June 18
USWG Meeting

Approval: Recommendations for Verifying Individual Stream Restoration Projects

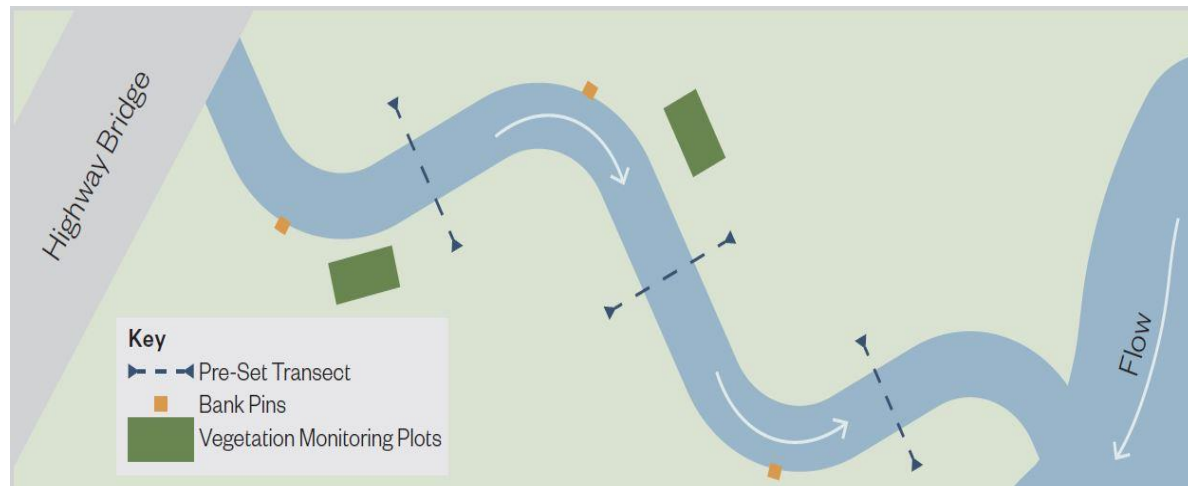
Q: How do you verify older stream restoration projects that were designed w/o the protocols and just used the default rate?   (Alana – WVDEP):

- Concern about aggradation as a visual indicator

- Use of terms such as severe or major for bank erosion

- Revised Note 7 on Table 8 (scott Cox, PADEP)
-
- How to verification of the actual boundaries of the hyporheic box (punted to Group 4)

A: Rely on the stability/erosion visual indicators for Protocol 1, since most historic projects were designed based on Rosgen natural channel design methods. May require some additional field work if post-construction documents are not available
